MEMO

136 Manuka Road, Oyster Cove: DA-2022-336
Comment on Section 8 of Kingborough Council RFI's
dated 4 July 2023 and 11 December 2023

Figure 2 (left). Plan showing proposed outbuilding with vehicle garage and storage. (Proposed site plan Harrison 002 of Hargreaves Design Group dated 3 August 2023)

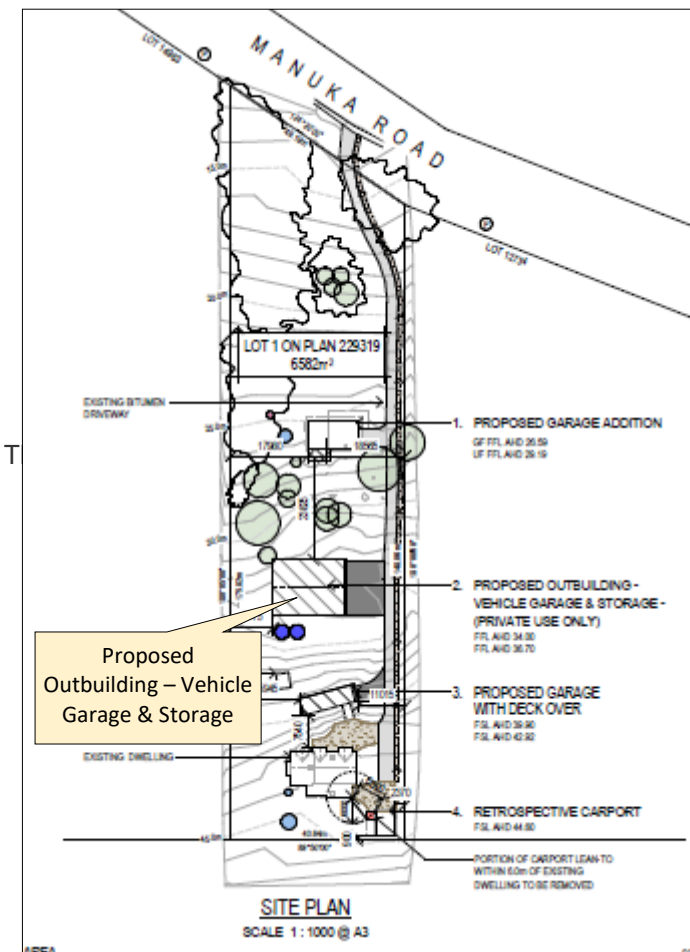
These measures have the potential to involve further development and works and result in additional impacts on trees, including tree removal. Accordingly, amended plans are required to demonstrate consistency with and incorporate these specific mitigation measures.

While the building itself is exempt from the Landslide Code, works do not benefit from this exemption and require assessment against the Landslide Code. In addition, where these works impact on native vegetation or require further tree removal, they require assessment against other standards of the Scheme, including Clause 14.4.3 P1 and E10.7.1 P1. The purpose of the requested information in this instance is to ensure the scope of works being relied upon to ensure landslide risk is low and acceptable are included in the application and any associated impacts on native vegetation are assessed as part of the application. In the absence of these works being clearly shown on the plans, it is not possible to undertake an assessment of these works and any associated impacts against the scheme requirements. In the absence of the works being included in the application, it is also unclear how the proposal meets the requirements of the Landslide Code. Identification and inclusion of works relied upon to address landslide risk is therefore integral to assessment of the application against the Landslide Code, Clause 14.4.3 P1 and E10.7.1 P1 and amended plans are required to demonstrate consistency with and incorporate these specific mitigation measures. Accordingly, amended plans are required to demonstrate consistency with and to incorporate these specific mitigation measures.

A retaining wall on the uphill side of the outbuilding is not essential, but a cutoff drain will be required to capture any upslope surface runoff and shallow subsurface seepage. Roof runoff from the building will be collected in the two 10kL rainwater tanks on the southwestern corner of the building (Figures 2 and 3). The cutoff drain water (if any) and tank overflow should be directed to the western side of the structure. No vegetation including trees will be disturbed in managing the water.

Covered in Section 2.2 above for the proposed outbuilding. The adjacent existing “proposed garage addition” (Figure 2) requires no extra surface drainage diversion away from it.
